Amongst other data, it contains splays, showing the visibility drivers would have from proposed drives off Lingards Road.

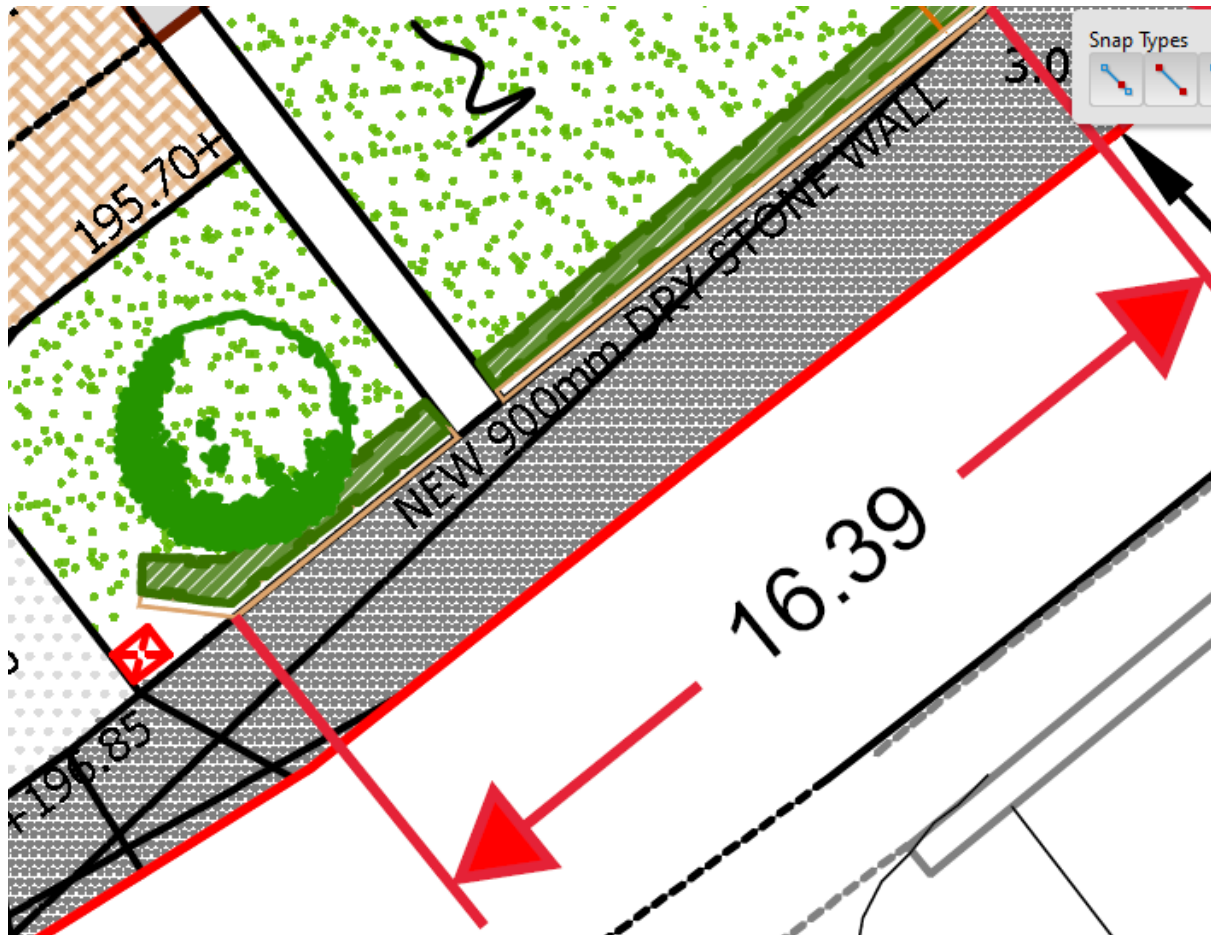
The thick yellow line is the splay for plot 37, looking north easterly, down Lingards Road.

The veracity and viability of these splays has to be seriously questioned, due to the brow of the hill.

Over half of these splays cover an area that would be out of sight, to any drivers using these respective drives.

Concerning plot 38, only 19 metres, of the required 43m, could provide visibility.

With a thinking distance of 9m and a stopping distance of 14m, at 30mph, any vehicle travelling at that speed, would probably not have enough time to react, to avoid an accident.

In addition to that, I strongly question the veracity of the splays as shown.

If you look at the same splay for plot 37 (although others suffer similarly), which is the yellow line mentioned above, you will see that 16.39m of it is shown passing through the stone wall that fronts the proposed dwelling.

Accepting drivers will not be able to see through the wall, looking where possible, their angle of visibility would be reduced by $\sim 2^\circ$.

The pink line below shows the proposed leftmost line of visibility, when I believe it would more likely be as depicted by the yellow line.

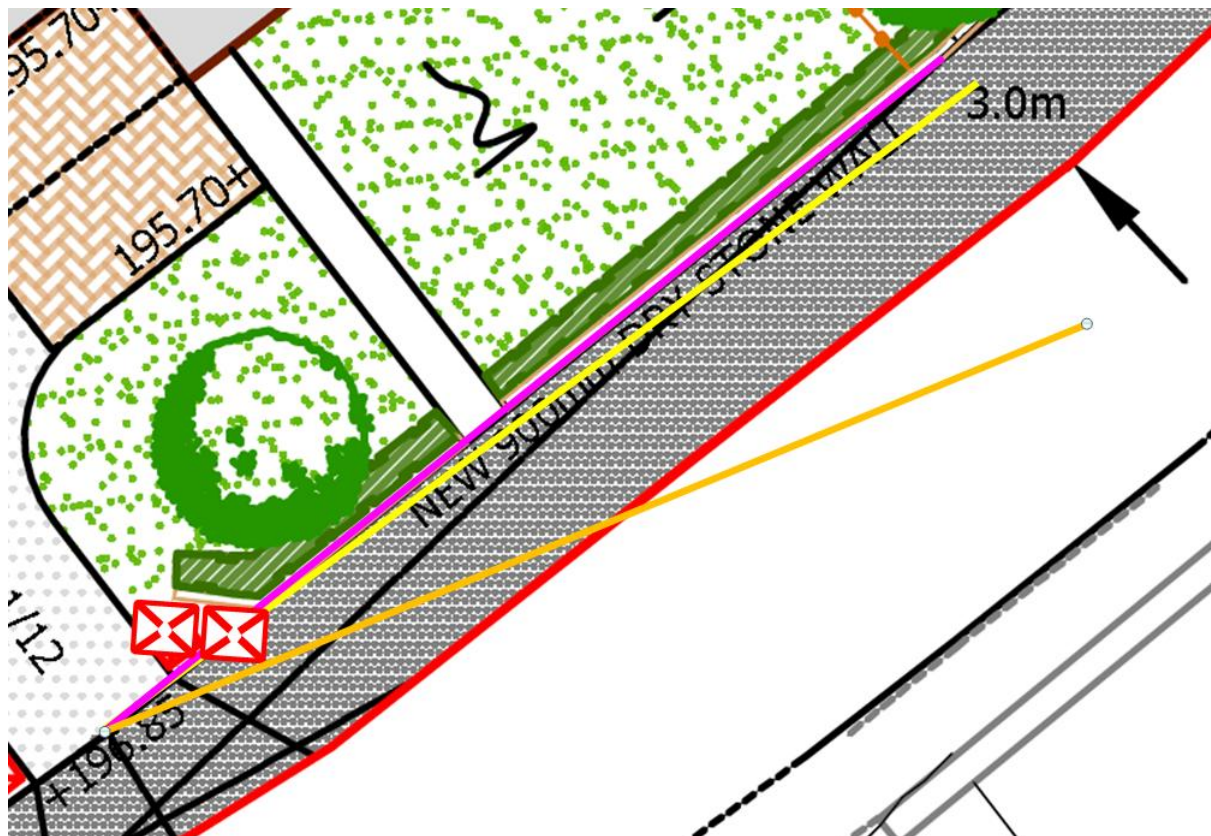
The splays also have to be questioned in relation to the wheelie bins planned to be positioned at the end of the drive.

As has been commented elsewhere, only one SMALL wheelie bin is allowed for on the plan, but two STANDARD sized wheelie bins are required.

Placing two wheelie bins, where planned, would, in my estimation, reduce driver visibility even further.

The image below depicts two standard sized wheelie bins, in the same location, and their affect.

The orange line now shows the driver's visibility restricted even more.

The difference between the pink and orange lines is now $\sim 17^\circ$.
